N5247A-02

S E R V I C E

N O T E

N5247A PNA Series Microwave Network Analyzers

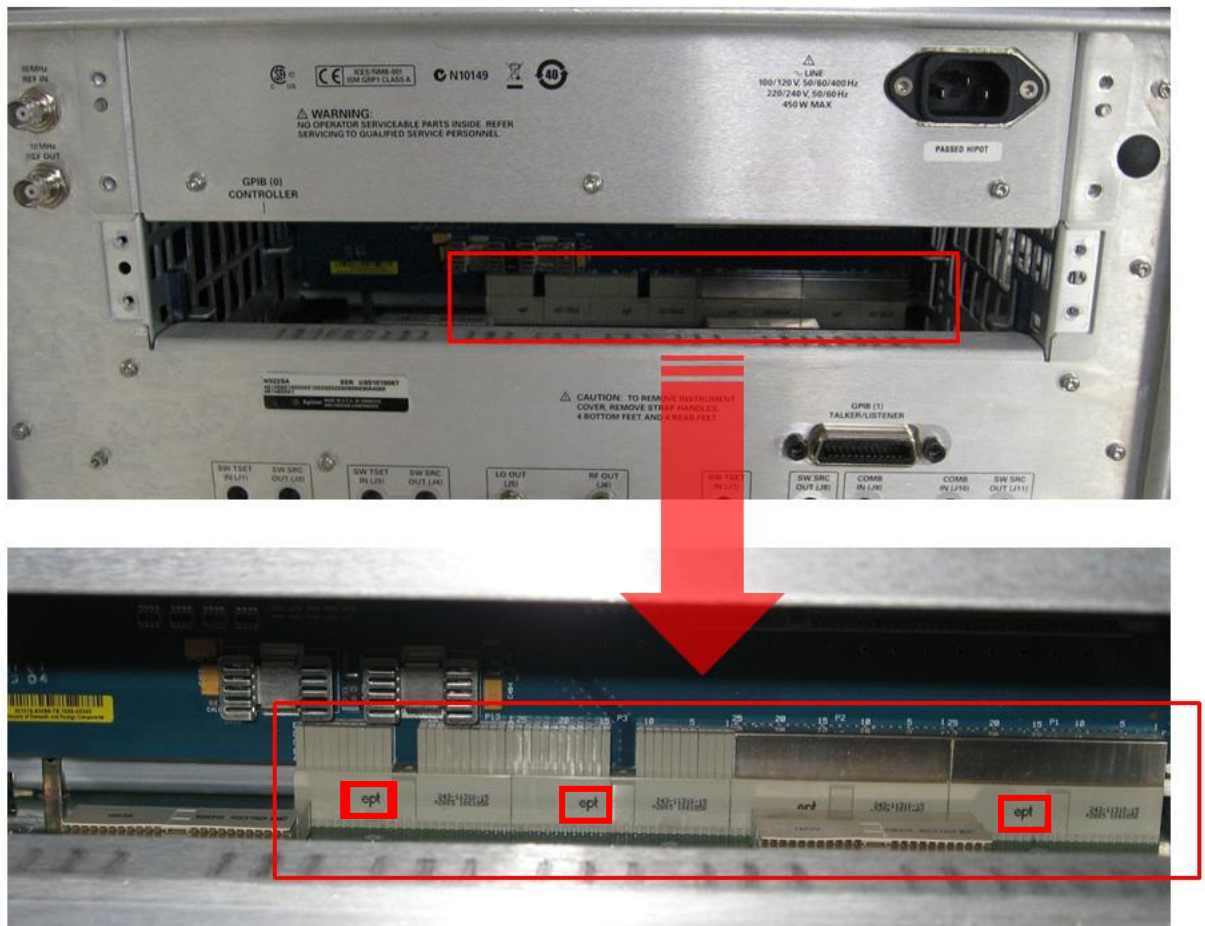
1. Remove the CPU assembly from the analyzer's rear panel. Refer to the PNA Service Guide chapter 7 section titled, "Removing and Replacing the CPU Board Assembly" for removal and reinstallation procedures. To view the online Service Guide, see the numbered list on the next page for instructions.
2. As per the photo below, inspect the system motherboard connector to see if it has one or more "ept" logos.

3. If the connector has one or more “ept” logos, return the analyzer to Agilent for replacement of the system motherboard. If the connector does not have one or more “ept” logos, email support_ctd-soco_support@agilent.com, providing the analyzer model and serial number and details of the malfunction symptoms.

4. *For Agilent Service Technicians only:* Only new boards without “ept” logos should be installed. Before installing the new board, look to see if it has one or more “ept” logos. If so, email support_ctd-soco_support@agilent.com, providing the analyzer model and serial number. Wait for further instructions in an email reply. New boards without “ept” logos can be installed.
For installation instructions, refer to the PNA Service Guide chapter 7 section titled, “Removing and Replacing the System Motherboard.” To view the online Service Guide, see the numbered list on the next page for instructions.
